## Landscape Referral Response

<b>Application Number:</b>	Mod2021/0793
<b>Date:</b>	02/02/2022
<b>Responsible Officer:</b>	Lashta Haidari
<b>Land to be developed (Address):</b>	Lot 101 DP 1209504 , 5 Skyline Place FRENCHS FOREST NSW 2086

Fig. 1 Mod Architectural Plans with terrace to Skyline PI. Fig 2. Mod Landscape Plan with terrace to Skyline PI.

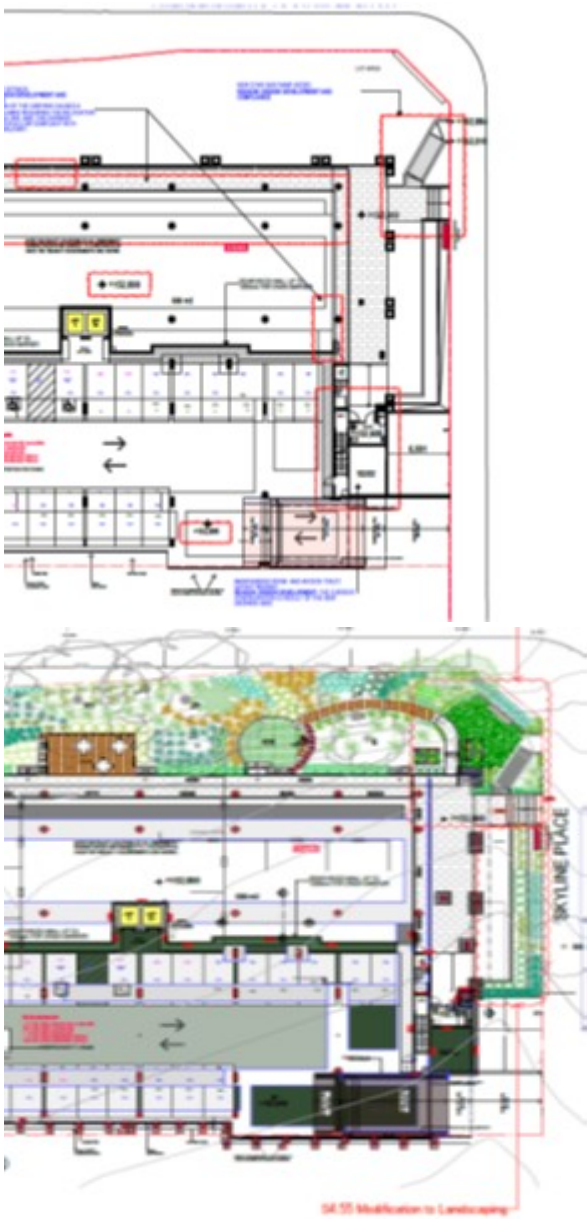
The Landscape Plans indicate reduction of approved soft landscaping in the setback to Skyline Pl. replaced with what appears to be an extended terrace adjacent to the commercial component (Figs. 1 and 2 below). Whilst the plans indicate terraced planters on the boundary, it is considered that the loss of approved deep soil planting in this setback area (Fig. 3) reduces the opportunity for softening of the built form, and reduction in provision of canopy trees commensurate with the bulk and scale of the building and the existing streetscape.

It is noted that the Architectural Plans do not indicate the need for the extended terrace, though other modifications are clearly annotated.

Amended Landscape Plans and Architectural Plans are noted. The plans and the accompanying letter from Keylan Consulting indicate that the issues raised previously have now been addressed.

No objections are therefore now raised with regard to landscape issues. Existing conditions are considered still relevant and adequate.

Fig. 4 Approved parking bays and soft landscape at rear of site.

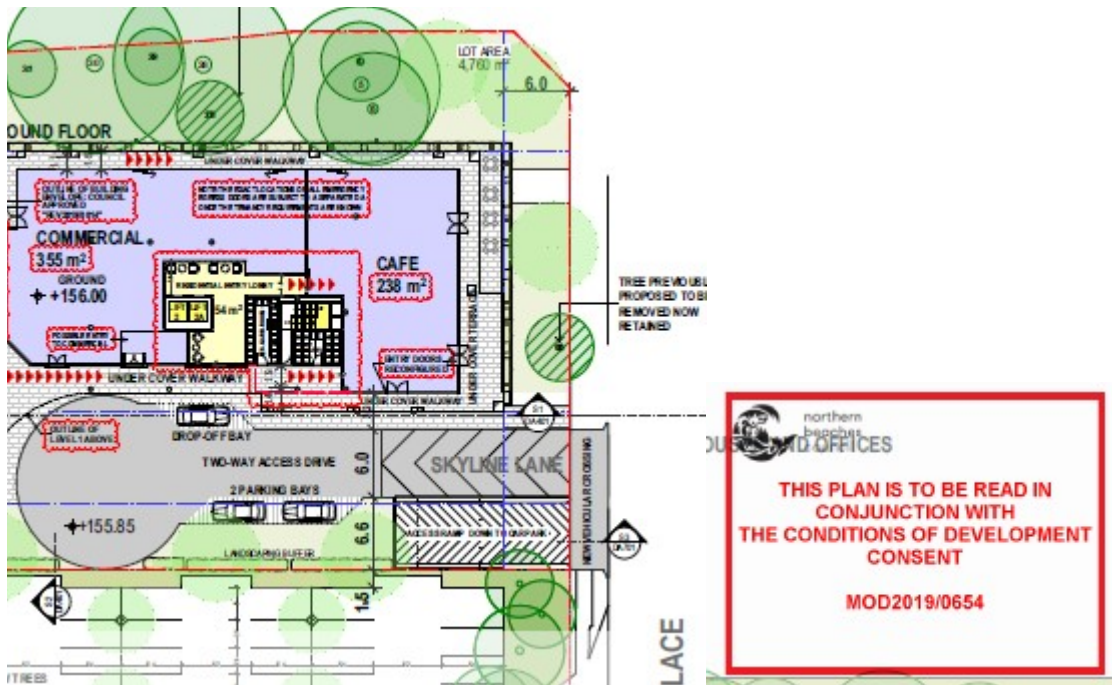
The plans indicate increase of parking bays at the rear of the site to service the commercial component (Fig 5). Provision of these bays deletes previously approved soft landscaping indicated on the approved and 'landscape buffer', providing relief between the sites and the approved carpark on the adjoining site. (Fig. 4)

The proposed modifications as described above are not supported with regard to landscape issues as the built form and hard components are extended at the cost of approved soft landscape works that were considered important in maintaining existing and desired character and providing softening of the significant built form.
